RE: **1940 Underhill Street (PID: 025-799-657)**
OCP Amendment, Rezoning, and Development Application

Date: July 20, 2018
File No.: Z18-0071
To: Urban Planning Management (AC)
From: Development Engineering Manager (JK)
Subject: 1940 Underhill St A1, C6 & P2 to C4

Response to Ministry Comments of January 11, 2019

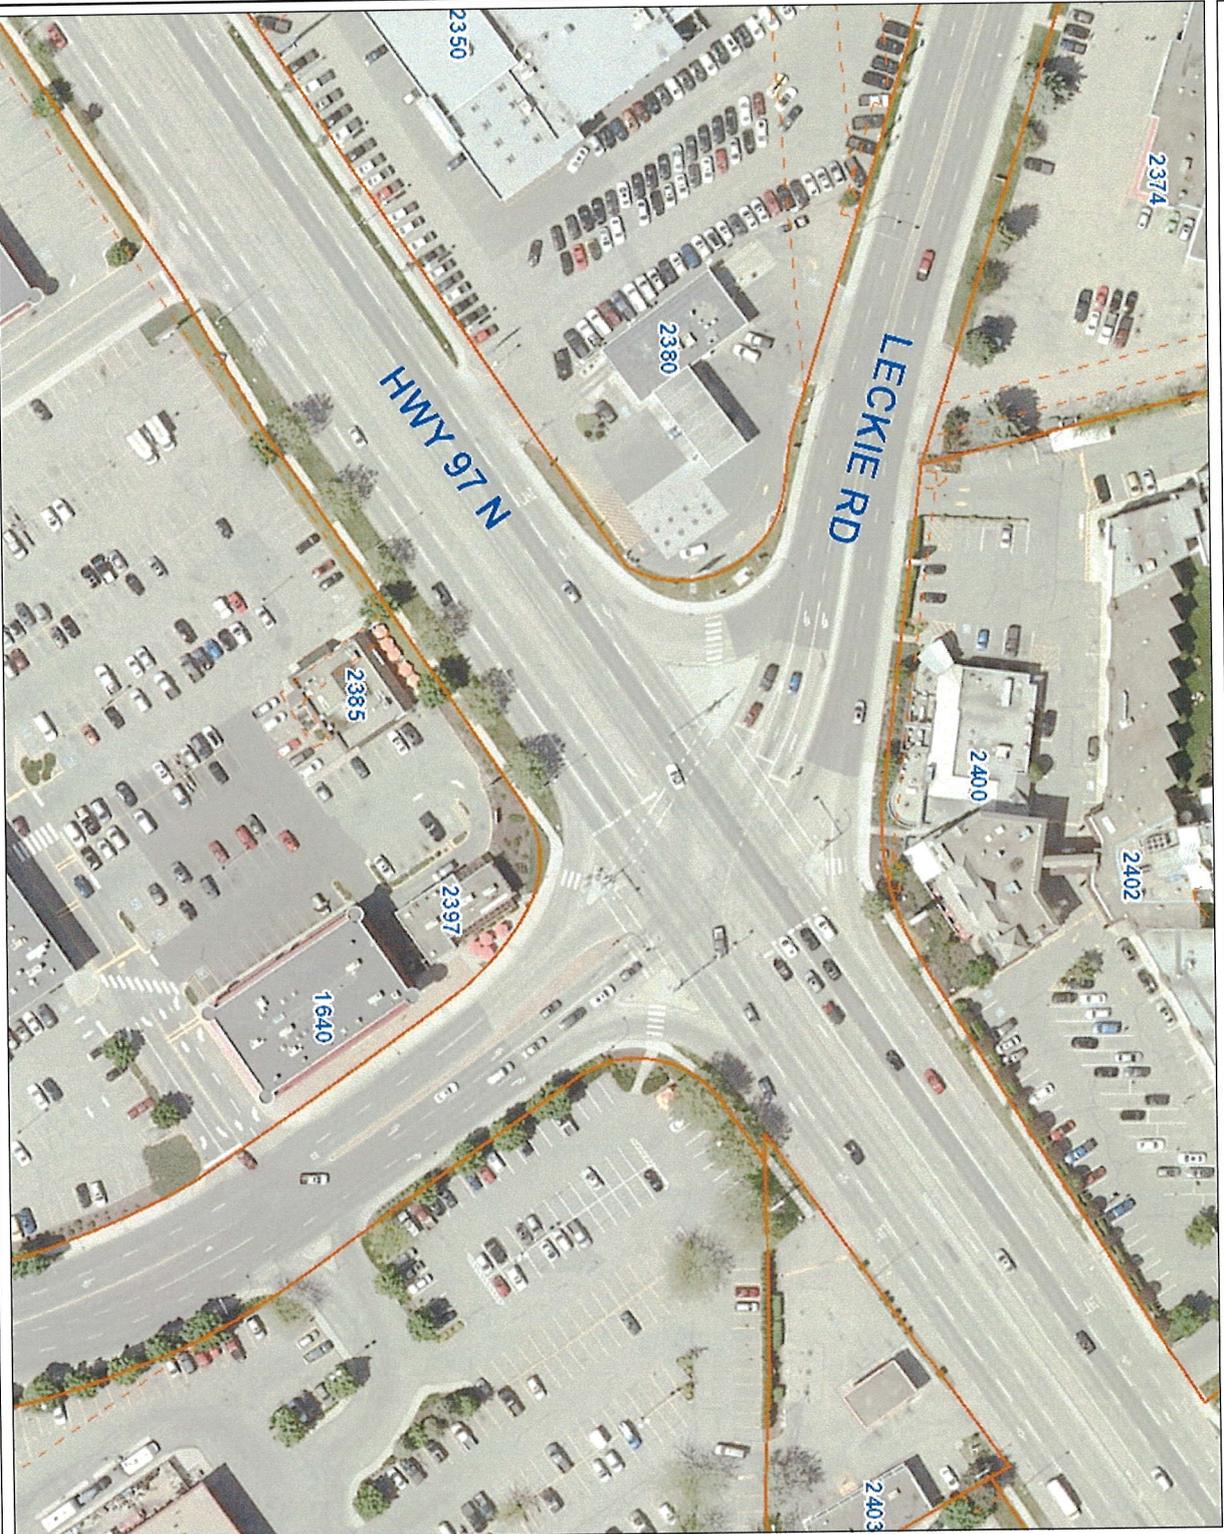
- (c) Provision of Eastbound Right Turn Lane on Highway 97 at Dilworth Drive: The City's webpage mapping indicates that may be possible to provide an eastbound right turn lane on Highway 97 for vehicles turning into Dilworth Drive – see mark-up on the aerial photograph of this intersection at the end. Although our analysis shows that this does little to improve the theoretical capacity of the intersection with the northbound left turn movement still being a problem, it would improve the practical operation of this intersection as well as the safety. From personal experience, often the eastbound curb lane along Highway 97 is stopped because a right turning vehicle at this intersection is blocked from making their turn because there are pedestrians crossing the turn lane. It only needs two automobiles or one longer vehicle (there is a storage length of no more than 9.0 metres) wanting to make the eastbound right turn being delayed by a pedestrian and the entire eastbound curb lane is stopped.

developer be asked to add an eastbound right turn lane on Highway 97 at Dilworth Drive. This will go a long way to improving the operation and safety of the eastbound traffic flow along Highway 97 since this movement at this intersection is one of the most congested along Highway 97.
